# WATERSIDE AT LAKE WOODMOOR

## SW 1/4 OF THE SE 1/4 OF SECTION 11 TOWNSHIP 11 SOUTH, RANGE 67 WEST, 6TH PRINCIPAL MERIDIAN EL PASO COUNTY, COLORADO PUD DEVELOPMENT PLAN/PRELIMINARY PLAN

# V3\_PUD Development Plan.pdf Markup Summary

### PUD MODIFICATIONS

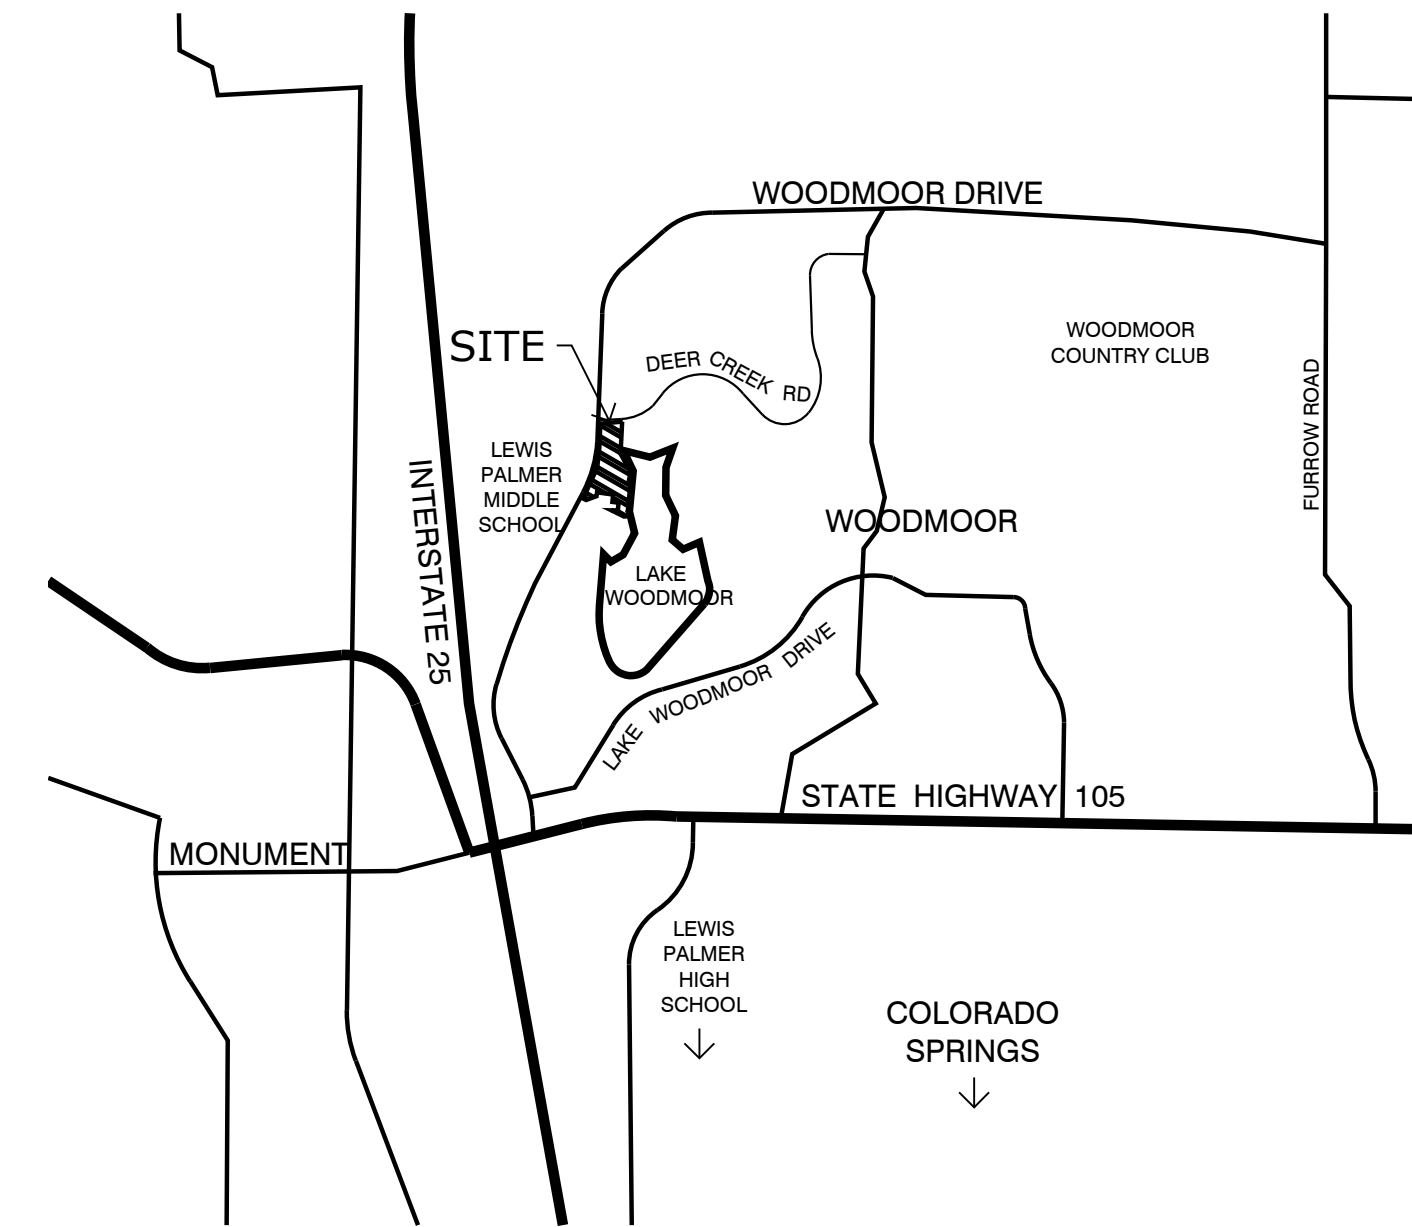
2. LDC Chapter 8.4.4(E)(3)	Private Roads to meet County standards.	Private roads shall be constructed and maintained to ECM standards.	Road width and roadway terminations (see 3 an 4 below)	
Typical Urban Local & [highlighted]			50' ROW with 30' asphalt mat (Local)

Include deviation for length of tangent between broken back curves (ECM 2.3.3.F.3) and width of pavement (Std detail SD 2-2). Even though road is a low volume local road, it still needs to meet the local road criteria. Both of these deviations can be included on the deviation request for the urban local cross section.

Typical Urban Local &

50' ROW with 30' asphalt mat (Local)

Include deviation for length of tangent between broken back curves (ECM 2.3.3.F.3) and width of pavement (Std detail SD\_2-2). Even though road is a low volume local road, it still needs to meet the local road criteria. Both of these deviations can be included on the deviation request for the urban local cross section.

(Local & Local Low Volume)

(Local & Local Low Volume)

### PUD SITE PLAN

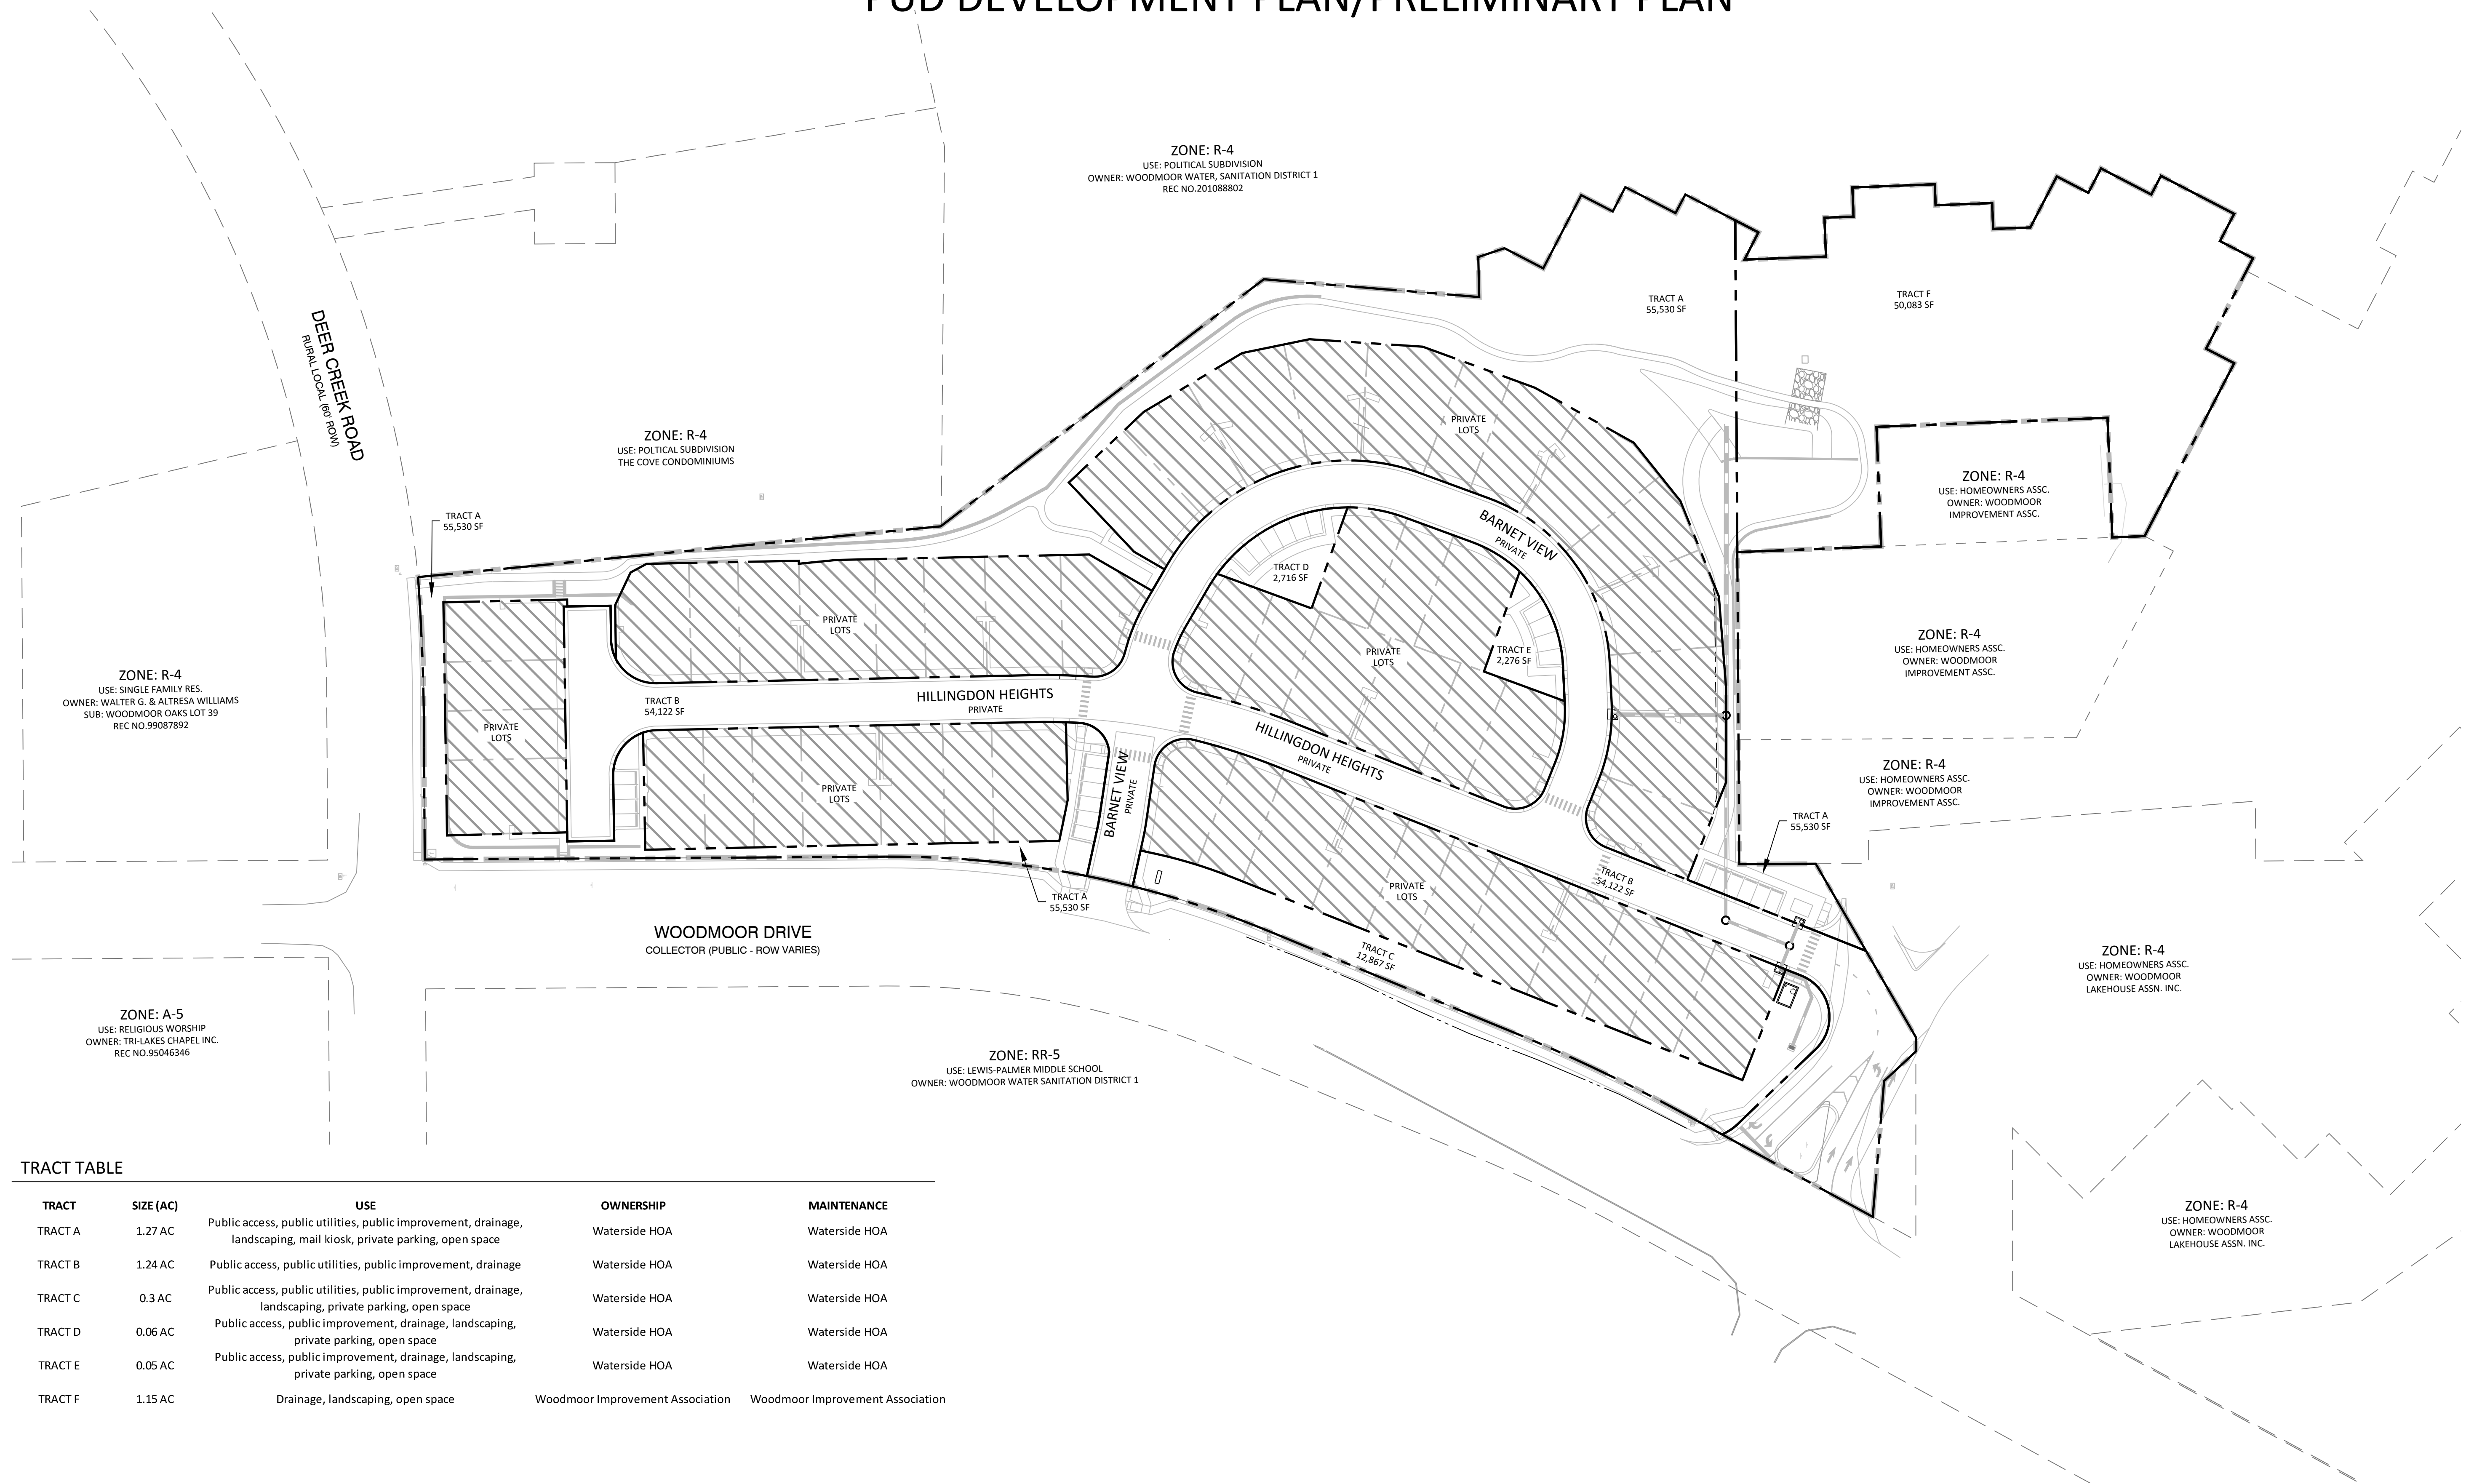
Per letter of intent, max wall height is 8'

Can't see linework behind hatch. Please lighten hatch or send "behind" linework.

Hard to tell where this easement goes

Based on spot elevations on grading plan, wall is greater than 4' in height

Label proposed wall & include max height

Label cross pans

**LANDSCAPE DETAILS**

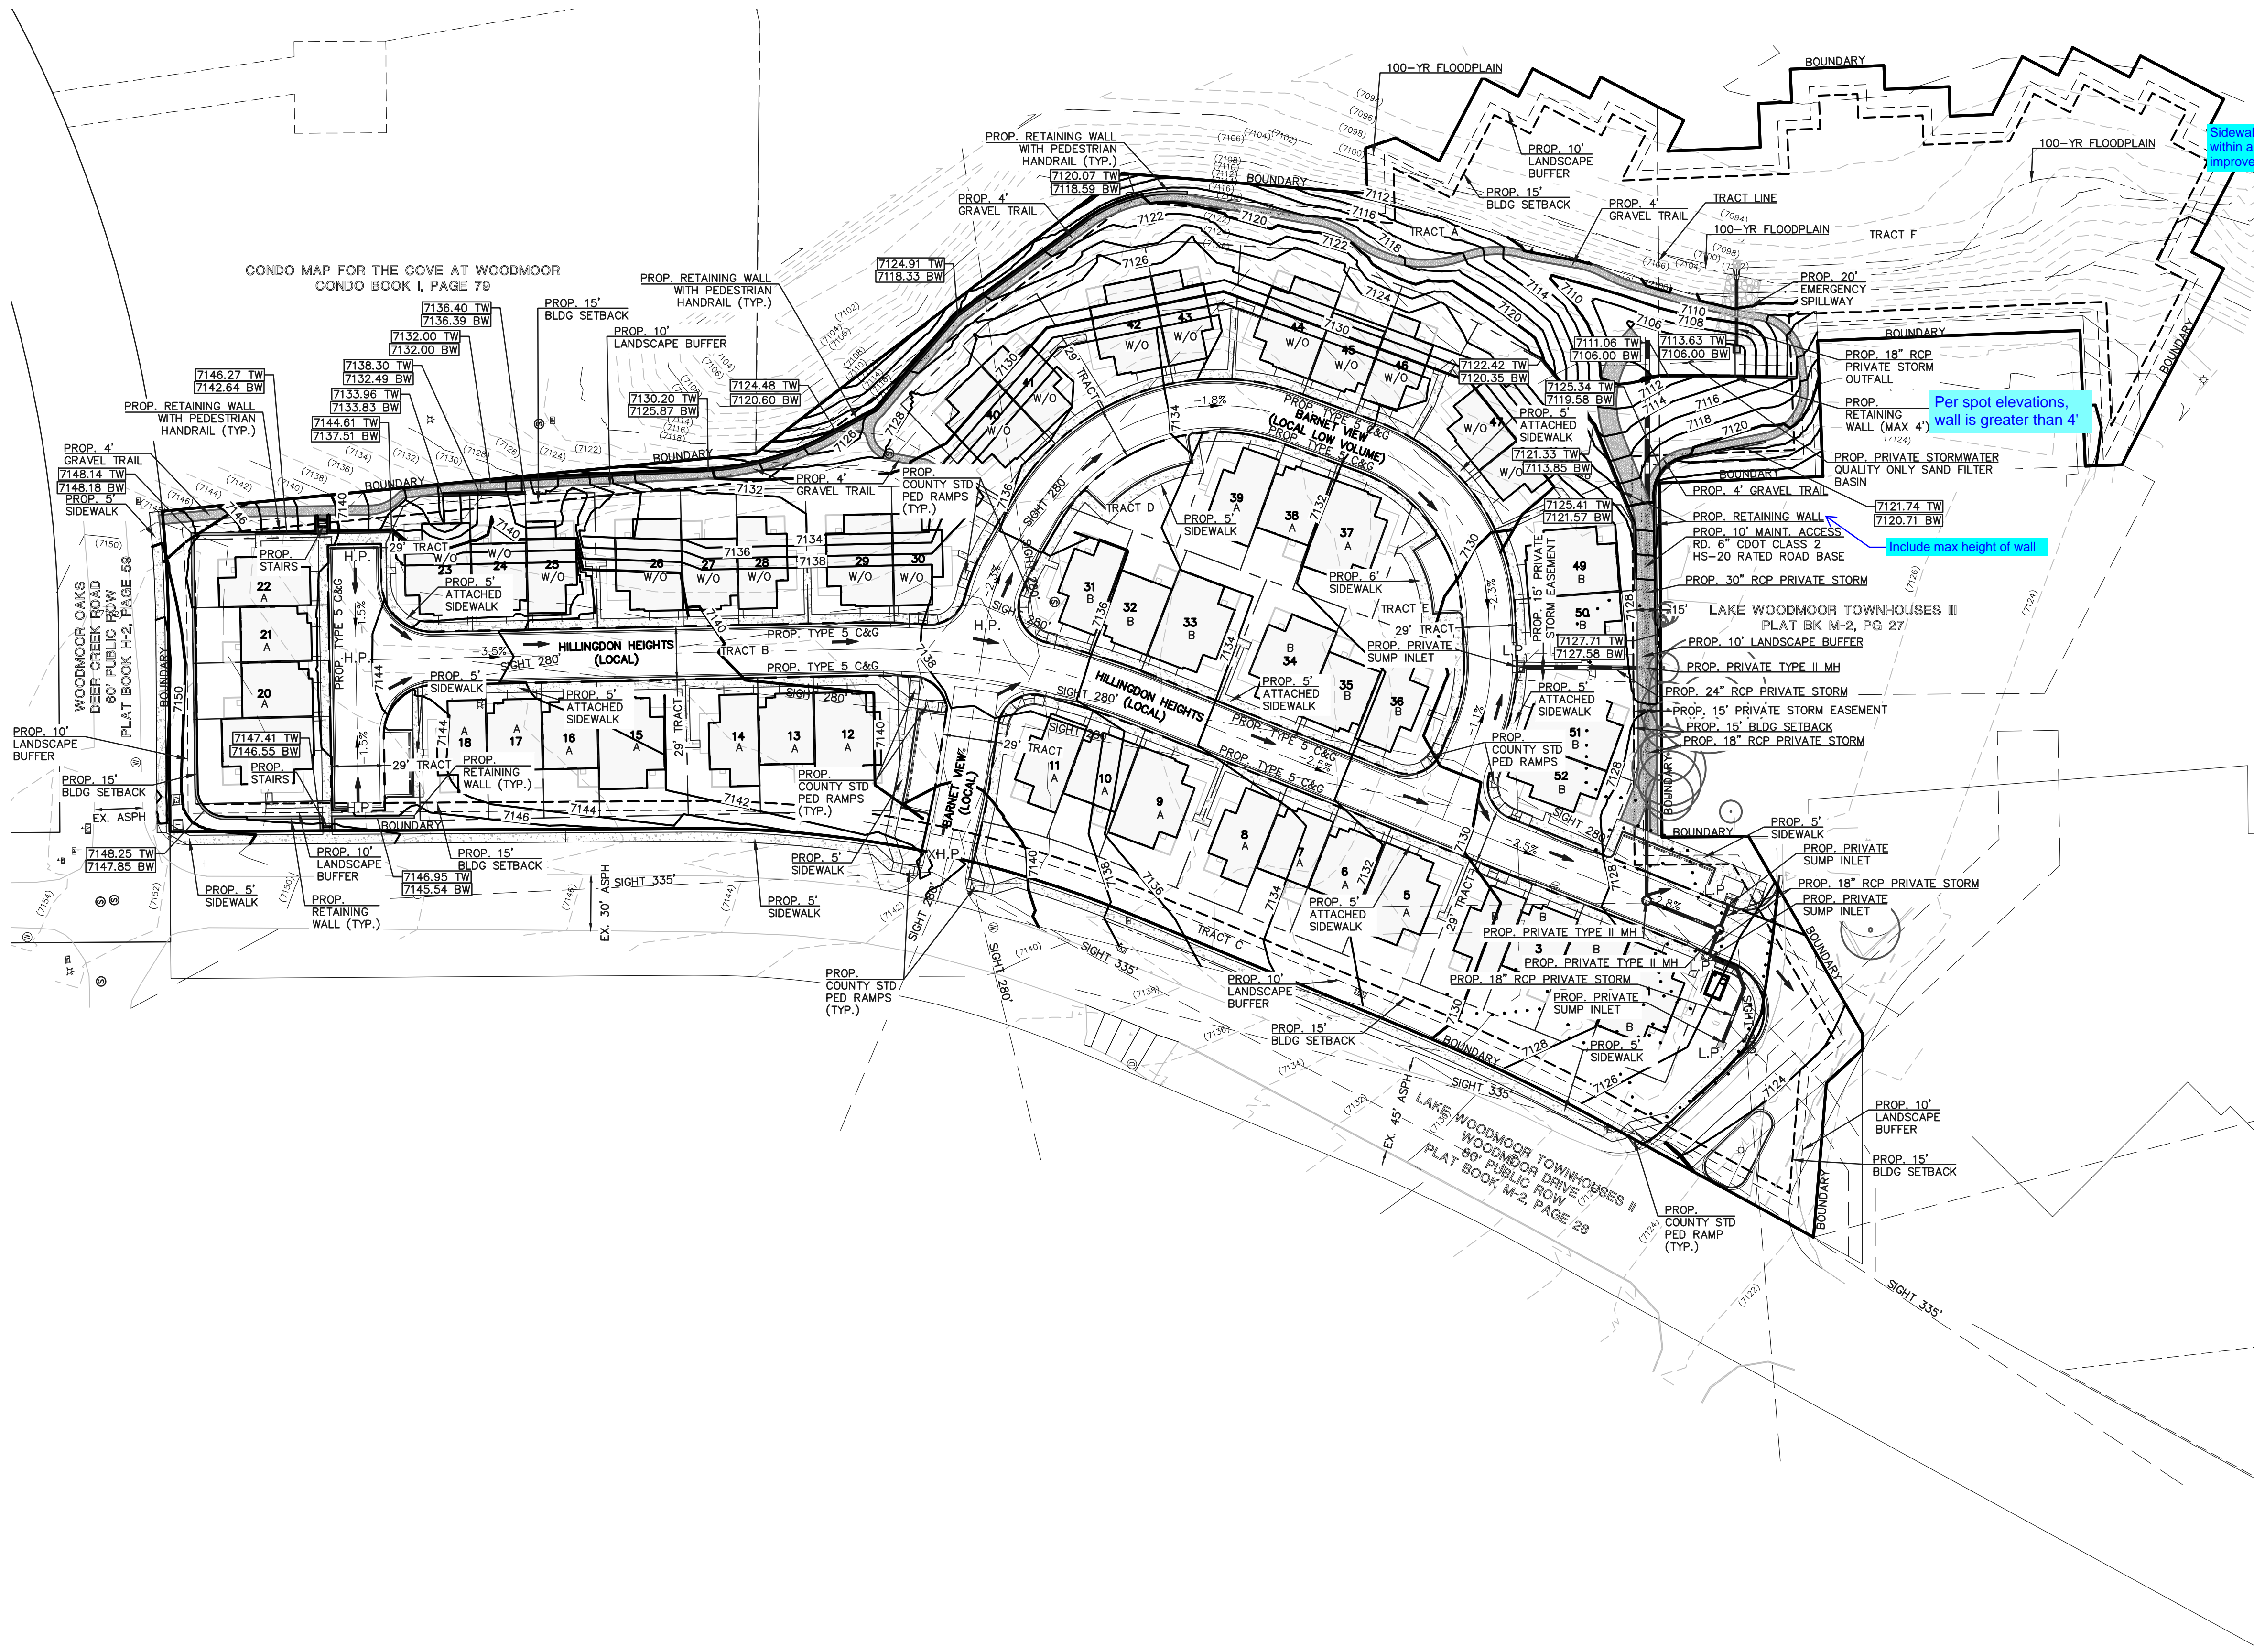
Sheet out of order

Sheet out of order
